UNITED STATES PATENT AND TRADEMARK OFFICE

APPLICATION NO.	FILING DATE	FIRST NAMED INVENTOR	ATTORNEY DOCKET NO.	CONFIRMATION NO.
09/939,647	08/28/2001	Shigeru Umehara	N99147USDIV	5529
21254	7590	12/01/2003	EXAMINER	
MCGINN & GIBB, PLLC 8321 OLD COURTHOUSE ROAD SUITE 200 VIENNA, VA 22182-3817			ALANKO, ANITA KAREN	
			ART UNIT	PAPER NUMBER
			1765

Office Action Summary	Application No.	Applicant(s)	
	09/939,647	UMEHARA, SHIGERU	
	Examiner	Art Unit	
	Anita K Alanko	1765

FIG. 2

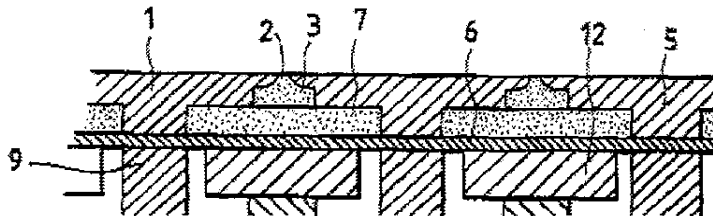
Kitahara discloses a method for manufacturing an ink jet recording head, comprising:
forming a pressure generating chamber 7 from a chamber plate with a pair of sides such that said pair of sides are substantially smooth surfaces (Fig.2), and

forming a plurality of ink outlet passages arranged into a pair of parallel rows (see Fig.2),

FIG. 7

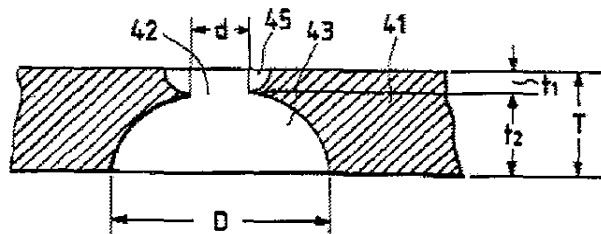
wherein said plurality of ink outlet passages comprise an upper passage portion 45 and a lower passage portion 43, and said upper and lower portions are each substantially hemispherical (Fig.7).

FIG. 37

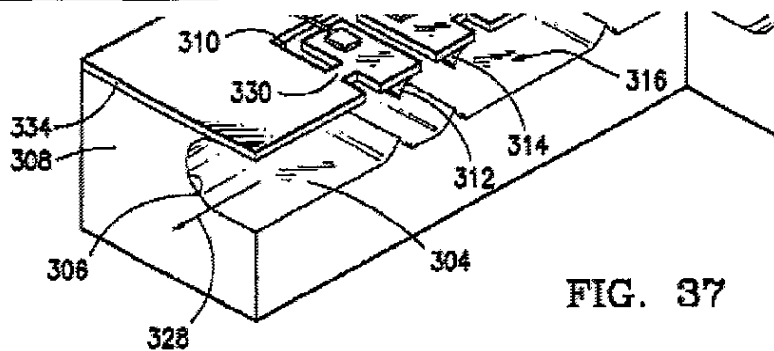
forming a pressure generating chamber (passageway through which ink flows from 300 to 306 in Fig.37 with pressure generated from heating by 320-322; analogous to 340 and 340' in Fig.40) from a chamber plate 302 with a pair of sides such that said pair of sides are substantially smooth surfaces (Fig. 37), and

wherein said plurality of ink outlet passages comprise an upper passage portion (top half surface of passageway, cross section seen as end face 308 in Fig.37) and a lower passage portion (bottom half surface of passageway, cross section seen as end face 308 in Fig. 37), and said upper and lower portions are each substantially hemispherical.

FIG. 40

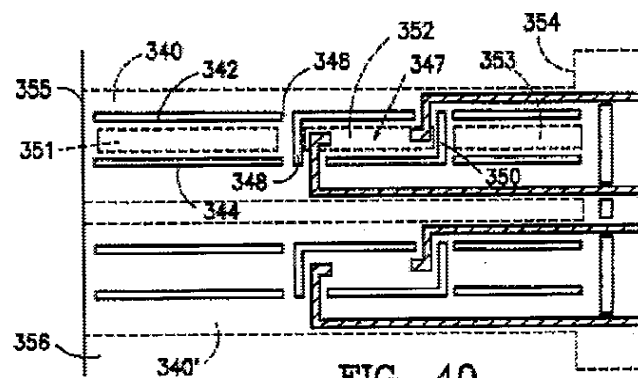
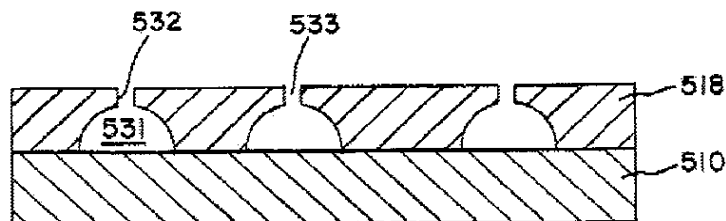
forming a plurality of ink outlet passages 340, 340' (Fig.40) arranged into a pair of parallel rows,
